TOF questions and concerns

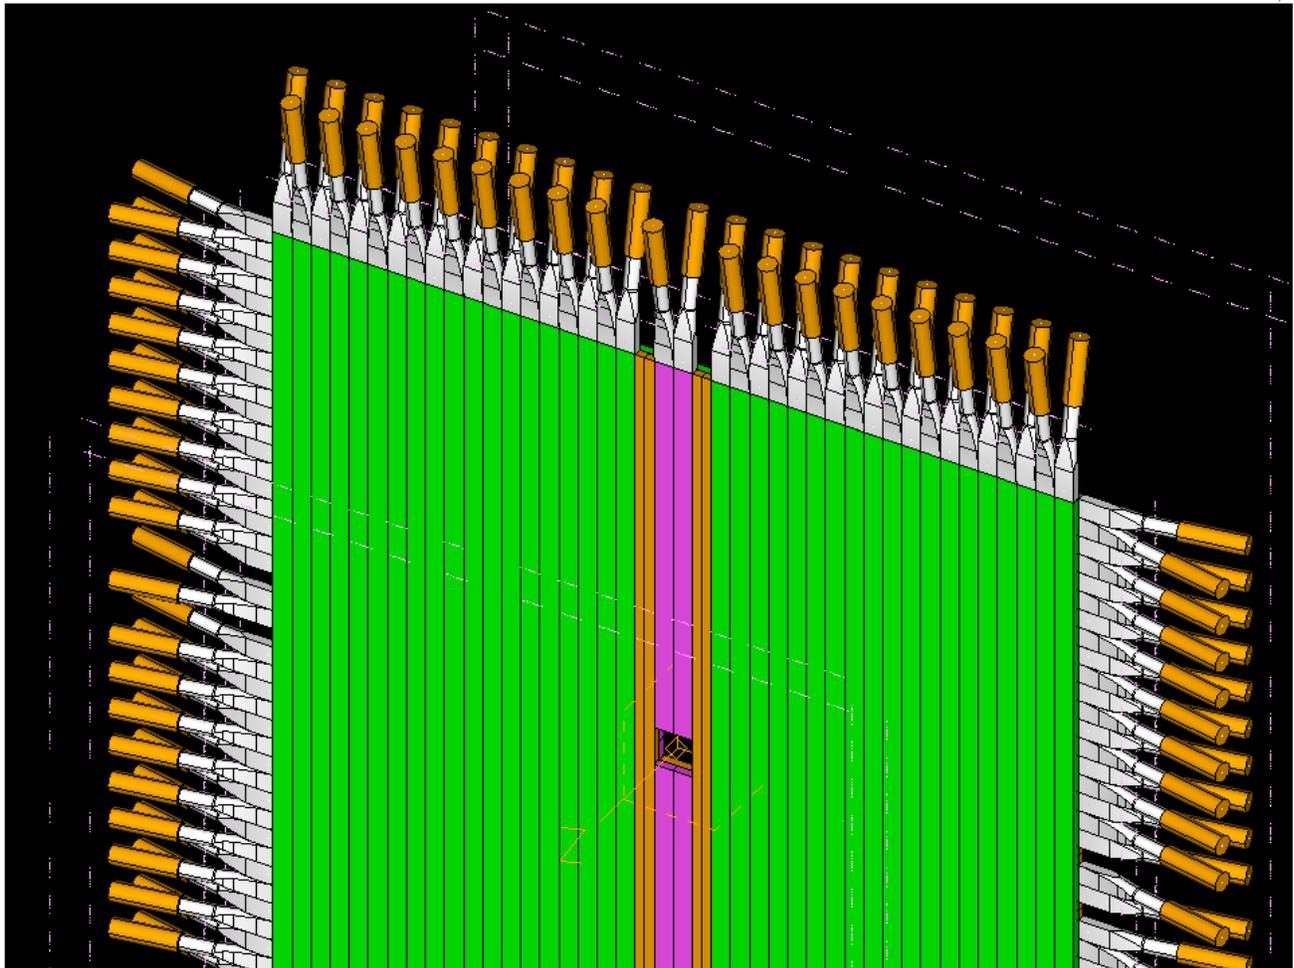
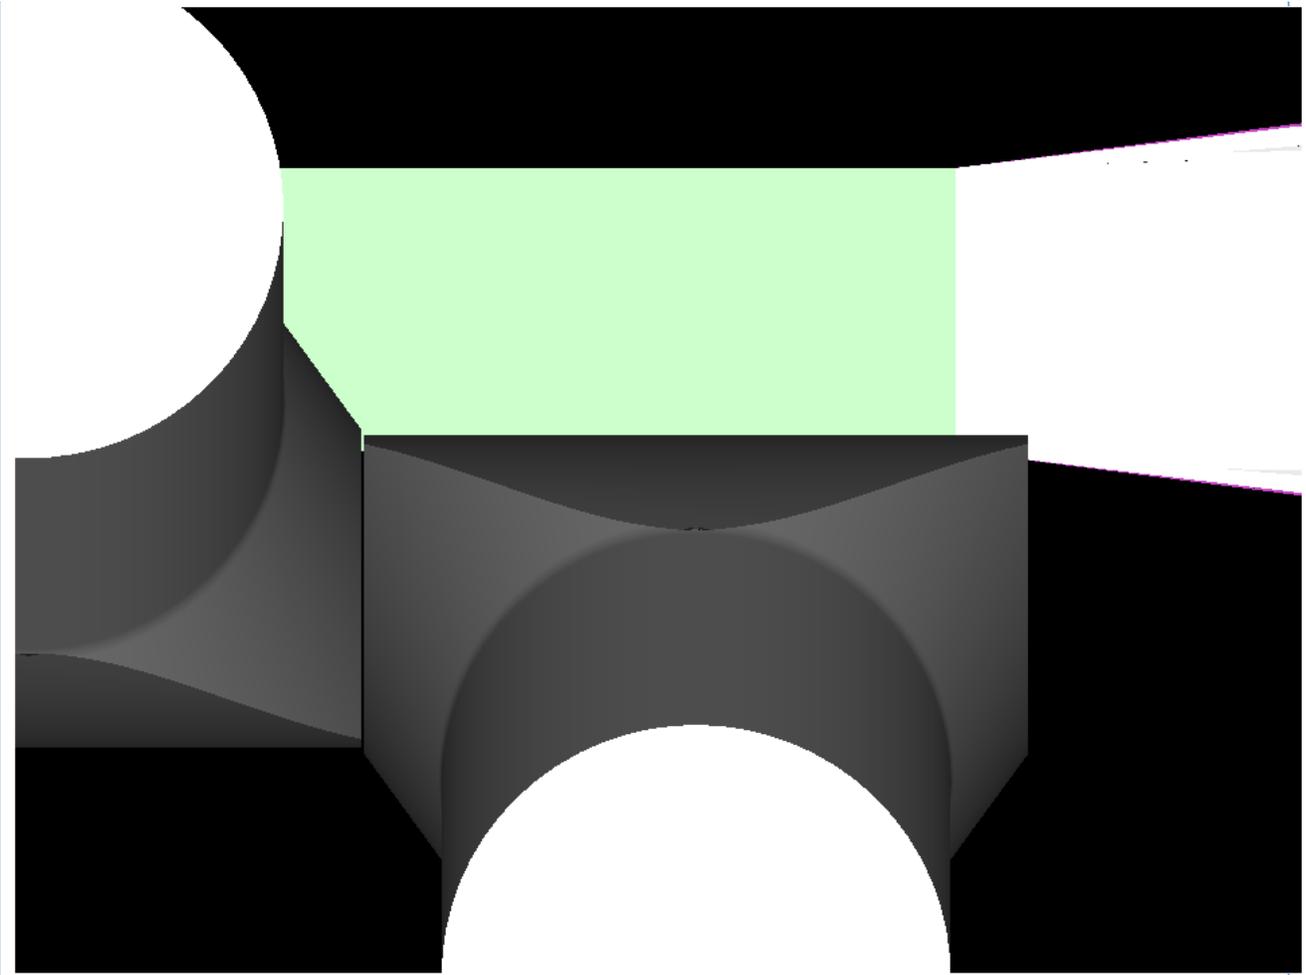
1) The current length of the long paddles are 252cm before adding the light guides to each end. I added in the wrap around each assy @ .006" thick on each lightguide bar assy. The overall width for the vertical layer shown in the picture for example now becomes 253.34 cm instead of 252cm so the two layers are not square anymore. The lightguide bends end up hitting the corner of the bar of the other layer at 252cm. We may have to lengthen the bar maybe another 1.5 cm to accommodate this so the layers can lay flush against one another as originally planned.

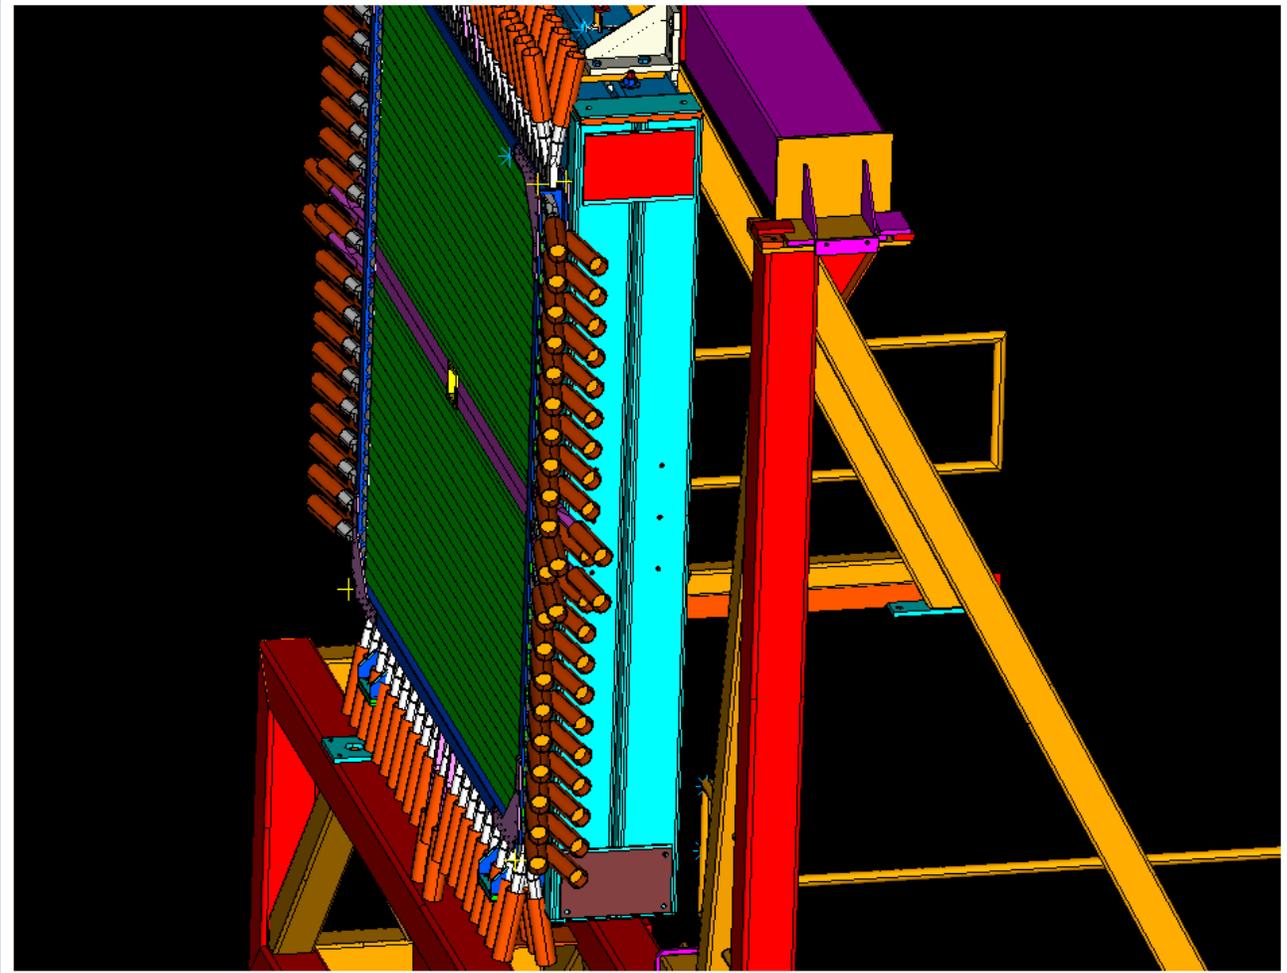
Another issue that I am noticing is that with the fishtailed light guides we may need to increase the space between the TOF and FCAL movable platform in regards to the mounting because of this also. It appears that the lightguides/shields in the vertical plane clip the corners now that they are angled verses straight. We may need to put a little more space in between them if possible.

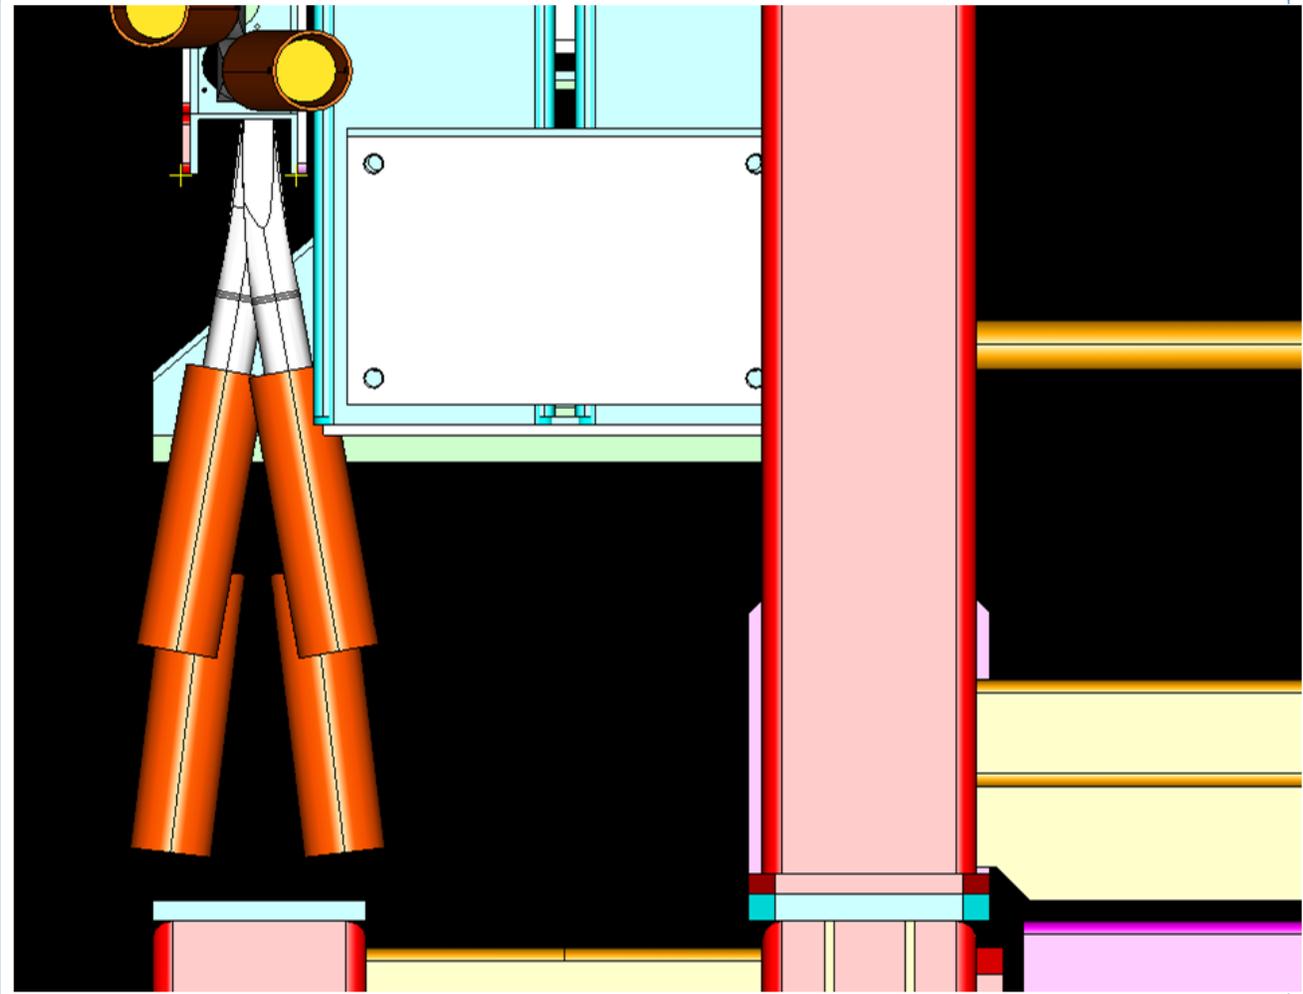
And last, the split lightguides stick out of course a lot further than the others. This may or may not be a problem in the bottom section as far as room for the wires etc, to come out. This is true only at the bottom of the TOF.
